## NURSING PROGRAM EXPANSION

WILLEY LIBRARY • JOHNSON CAMPUS

END OF ADDENDUM #3

### **CHANGE REQUEST**

**E-1.21**

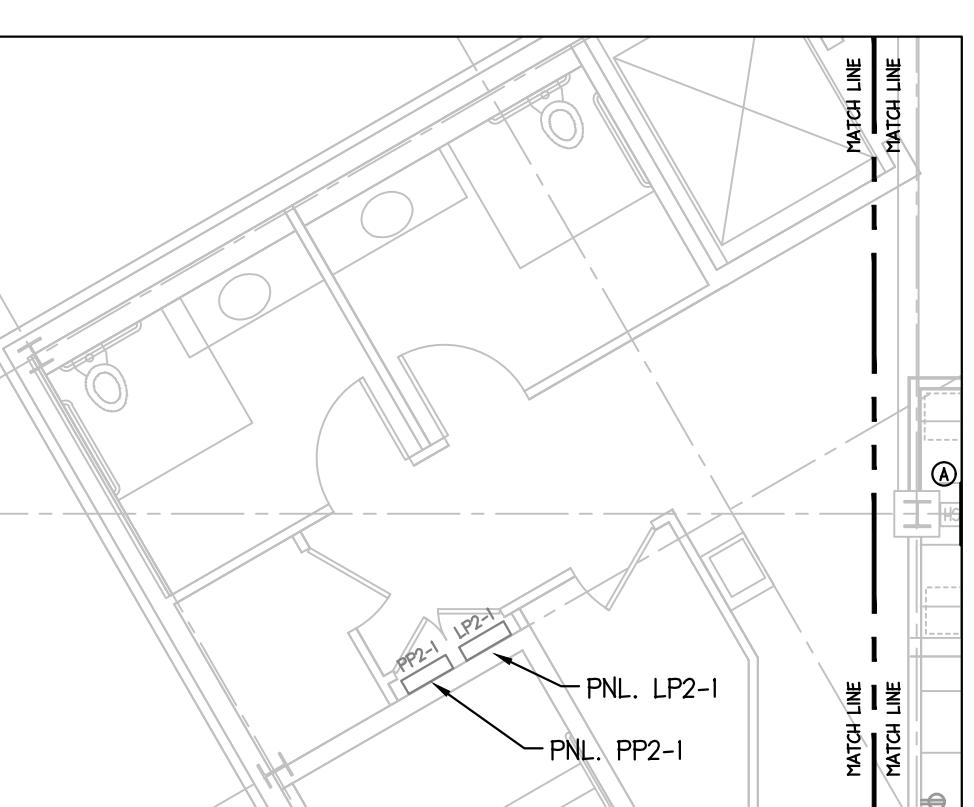
1. Dwg. E-1.21 Electrical – Second Floor Power & Special System New Work Plan;
  - a. Skills Lab 217 - Delete the proposed smoke detector.
  - b. Storage 217A - Delete the proposed smoke detector.

- c. Skills Lab 217 - Delete the proposed smoke detector.
  - d. Copy 218 - Delete the proposed smoke detector.
  - e. Exist. Comm - Delete the proposed smoke detector.

- f. Storage 233 - Delete the proposed smoke detector.
  - g. Storage 241- Delete the proposed smoke detector.
  - h. Skills Lab 242 - Delete the proposed smoke detector.

- i. Control Room 243 - Delete the proposed smoke detector.
  - j. Debrief 244 - Delete the proposed smoke detector.
  - k. New smoke detectors to remain in Hall 233, Hall 236 and Common Space 236A.

E-1.22

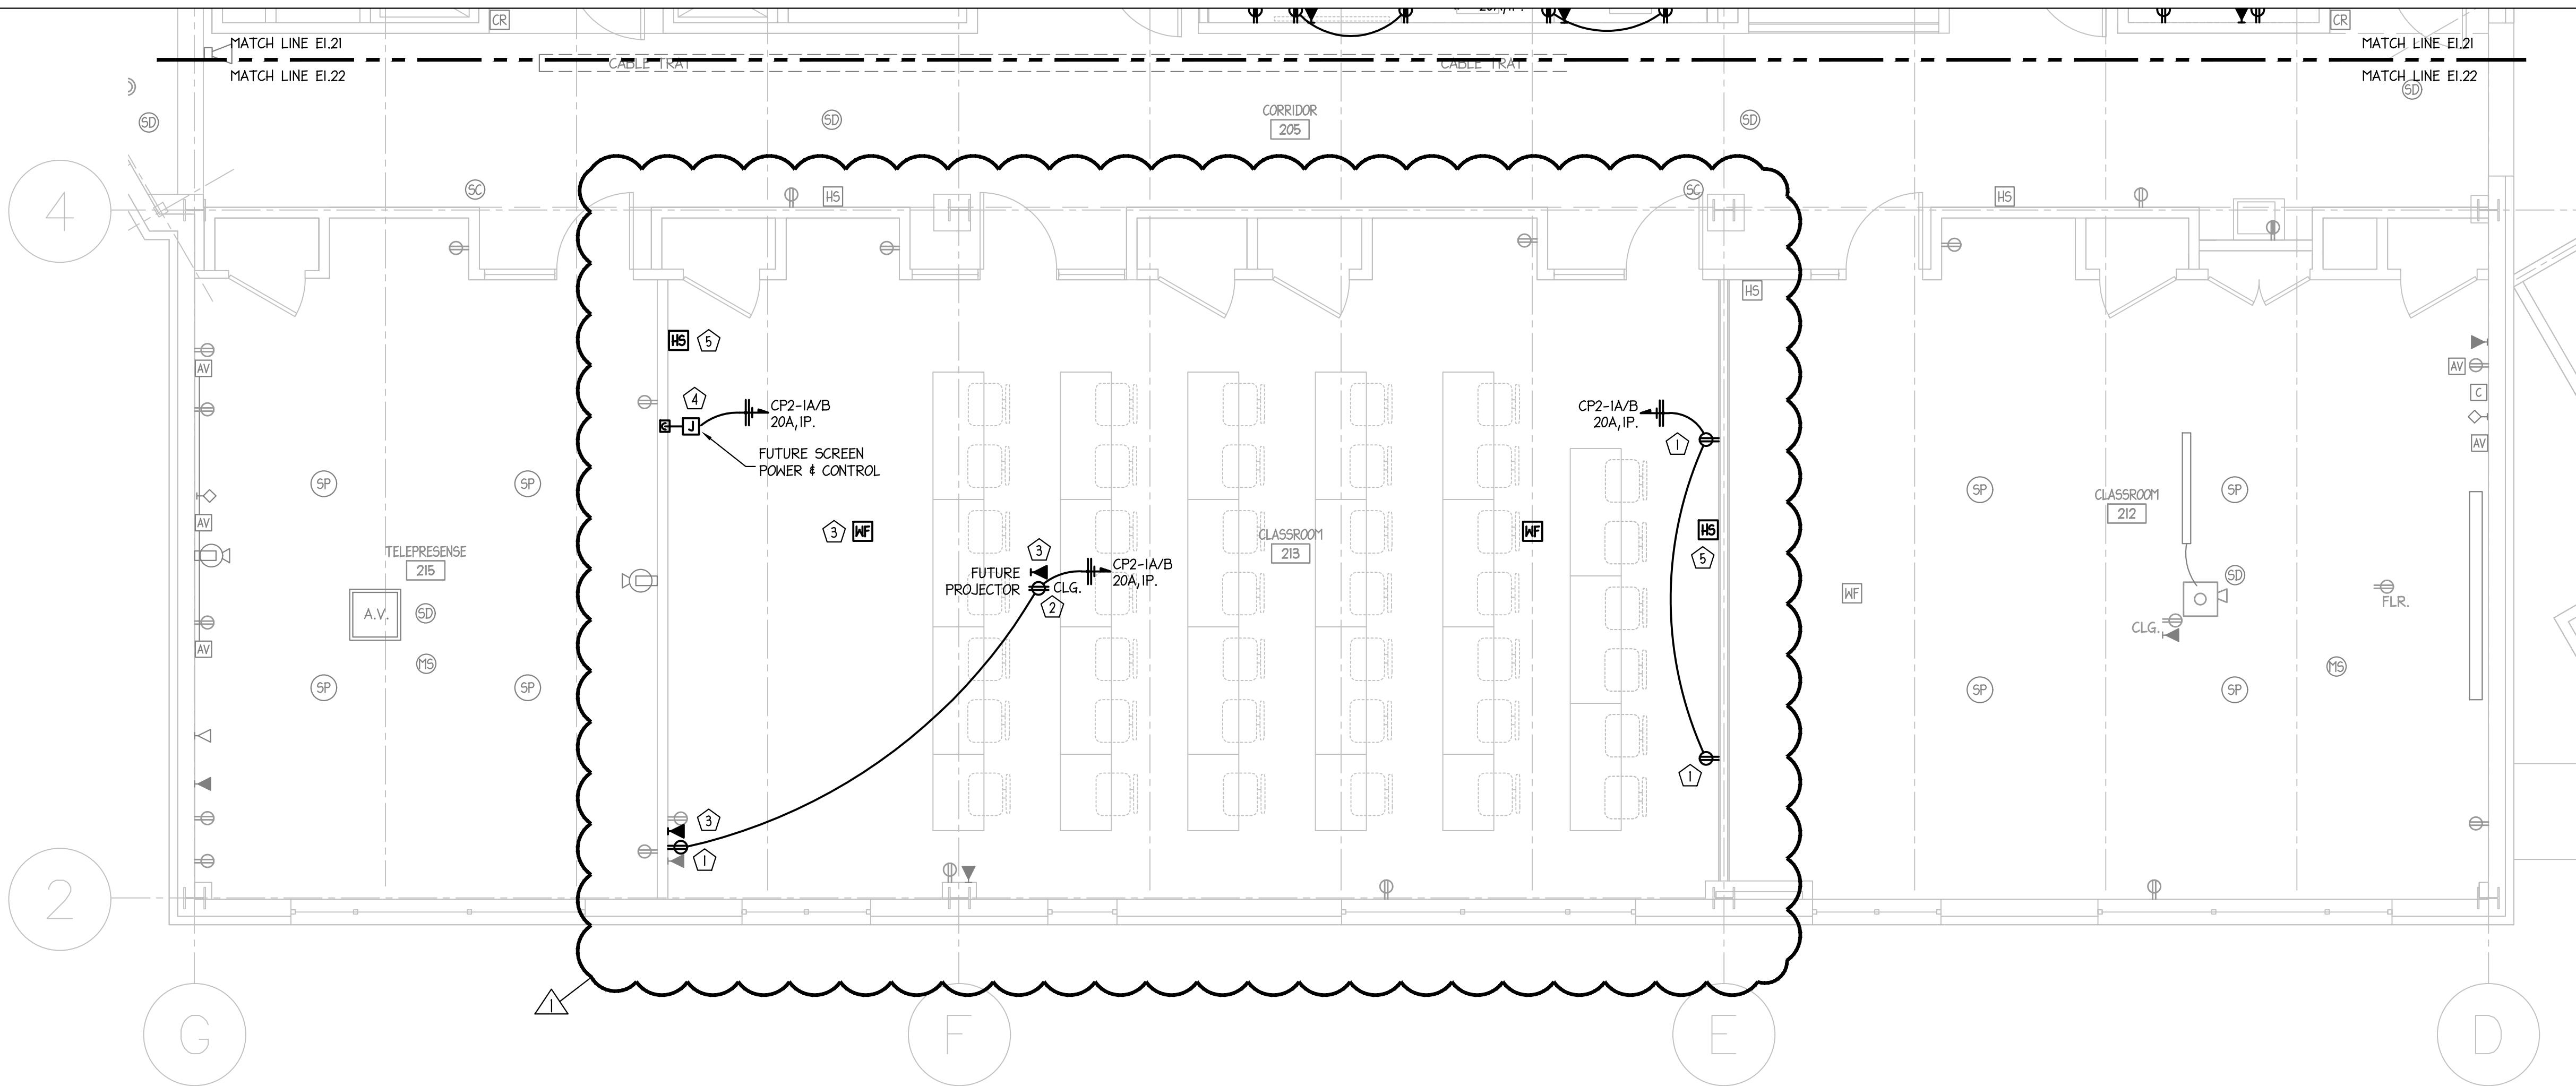
2. Dwg. E-1.22 Electrical – Second Floor Power & Special System New Work Plan;
  - a. Classroom 213 - Delete the proposed smoke detectors.
3. Dwg. E-1.41 Electrical – Penthouse Level New Work Plan;

E-1.41

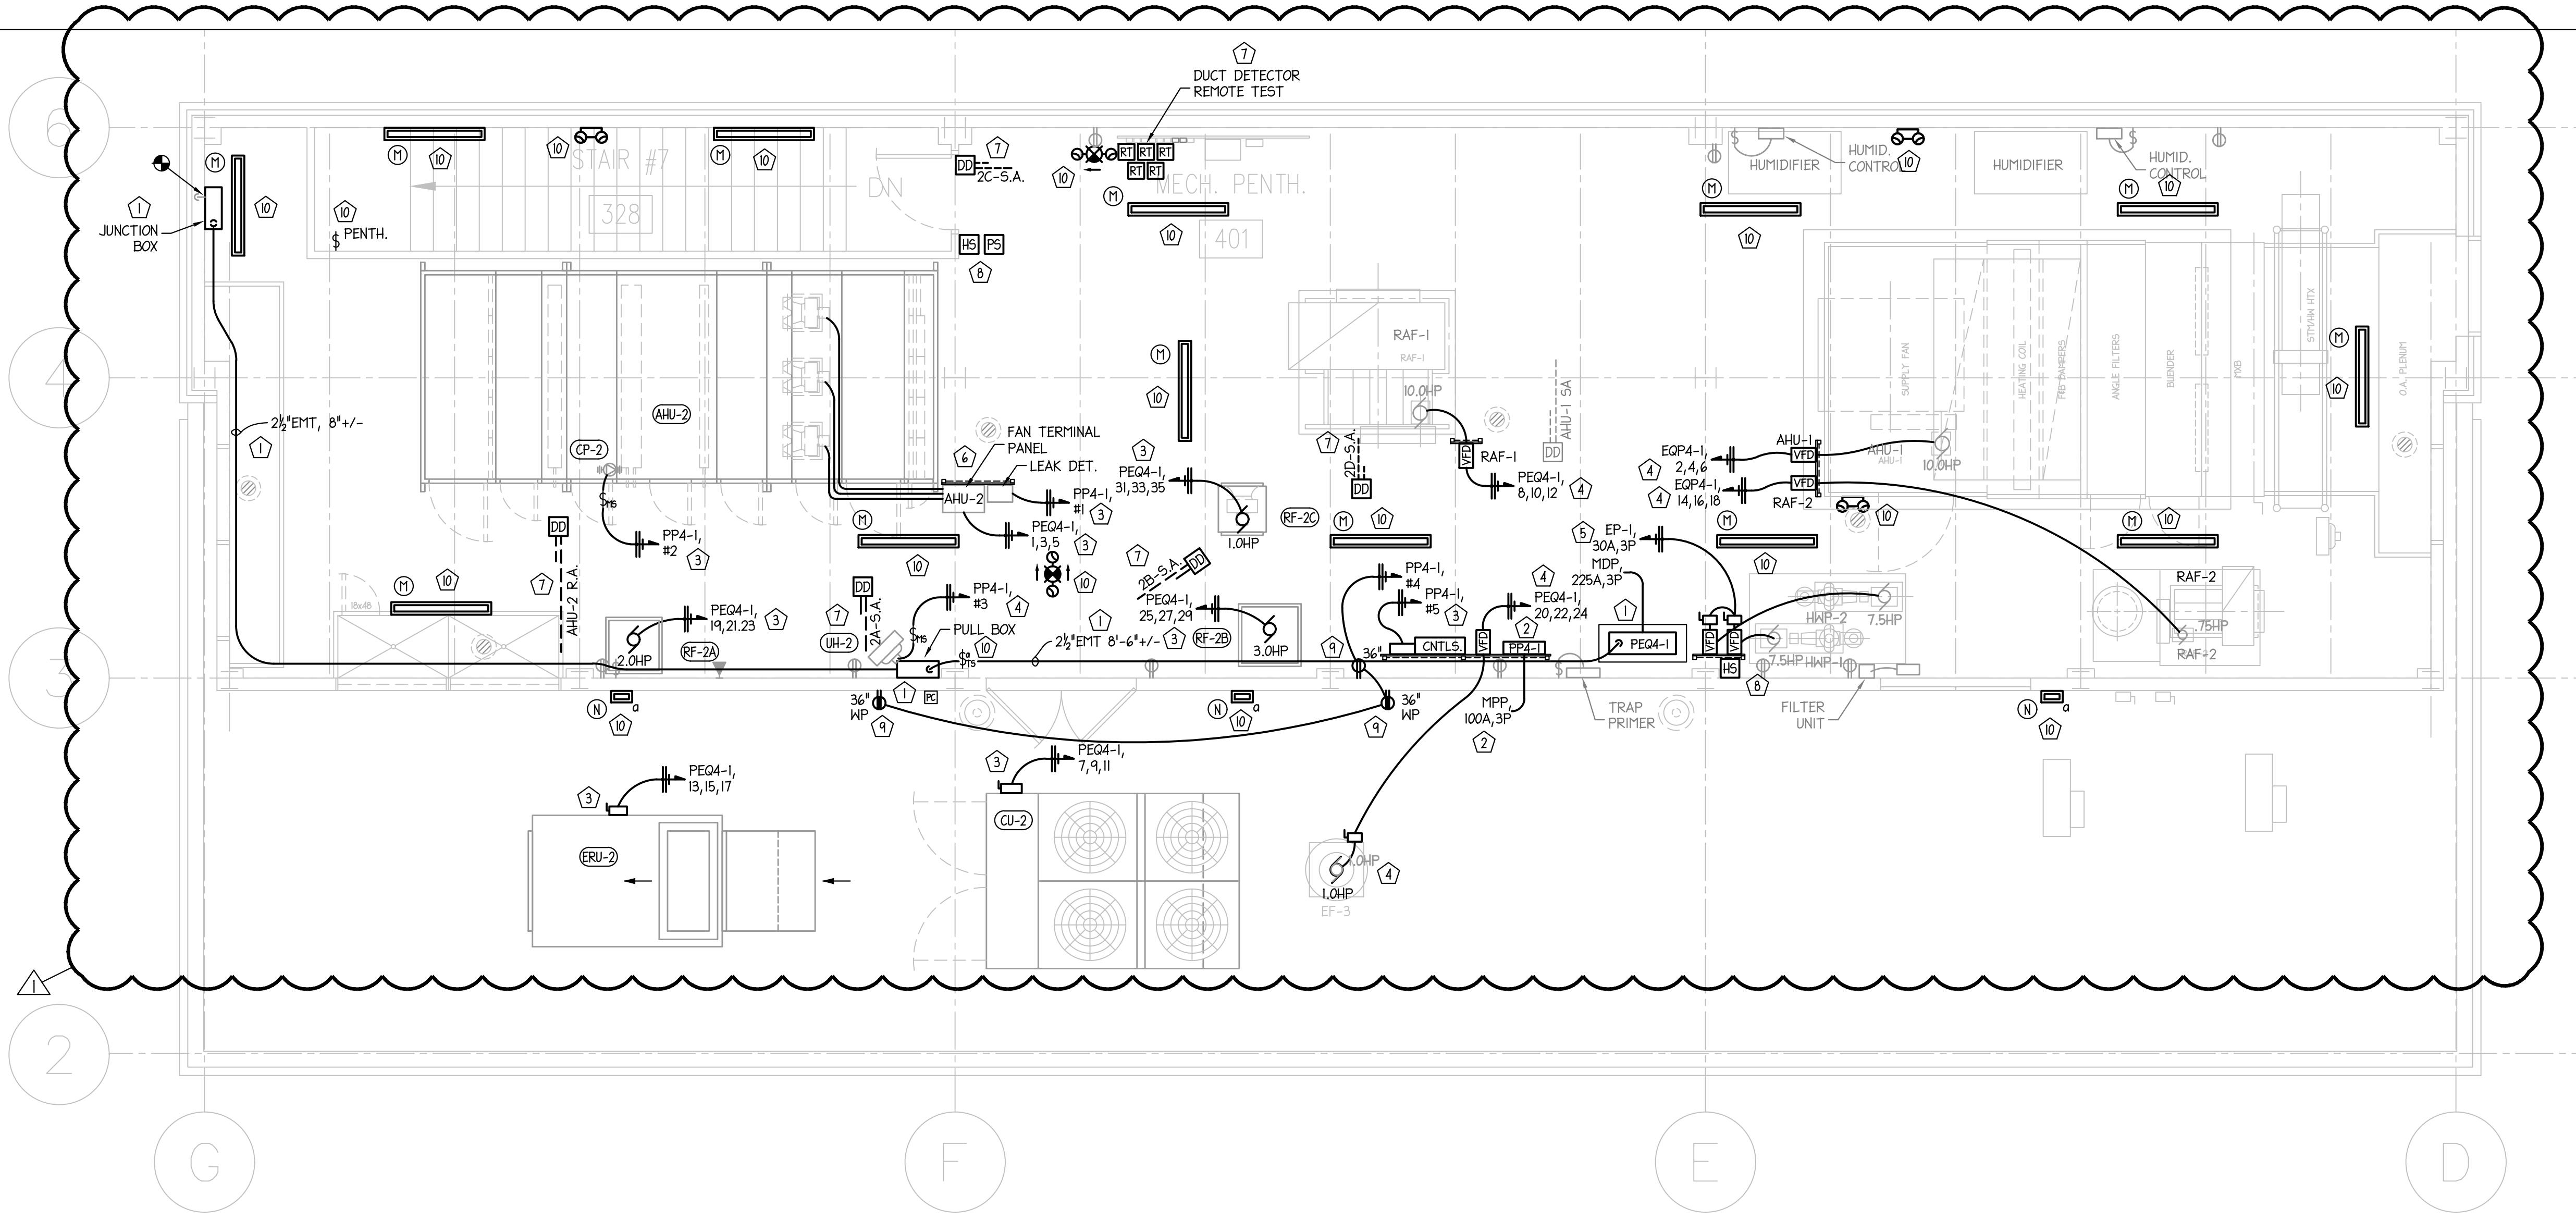
- a. Delete all proposed ceiling/deck mounted smoke detectors.
  - b. Note; All proposed duct smoke detectors to remain in scope.
